Comment Report

Project Name: 2020-02 Modifications to PRC-024 (Generator Ride-through) | Draft 2
Comment Period Start Date: 6/18/2024
Comment Period End Date: 7/8/2024
Associated Ballots: 2020-02 Modifications to PRC-024 (Generator Ride-through) Implementation Plan AB 2 OT
2020-02 Modifications to PRC-024 (Generator Ride-through) PRC-024-4 AB 2 ST
2020-02 Modifications to PRC-024 (Generator Ride-through) PRC-029-1 AB 2 ST

Tables 1 and 2 and numbered item 8

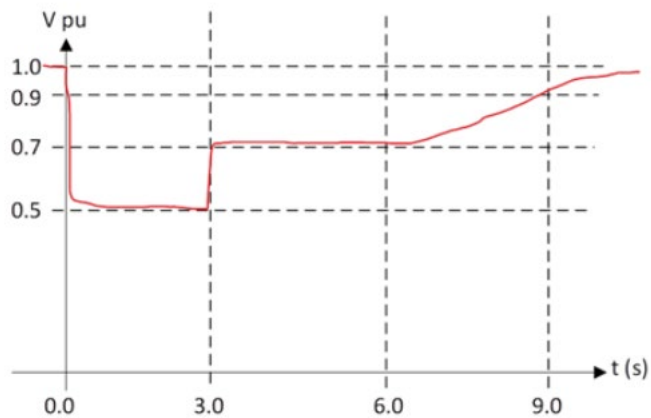
By using voltage bands (e.g., $0.7 \leq V < 0.9$) and time durations this results in a much more stringent requirement than IEEE 2800-2022 Clause 7. The SDT should consider removing the voltage bands to align with IEEE 2800-2022 Clause 7. Take this example where the red is a fictitious voltage plot:
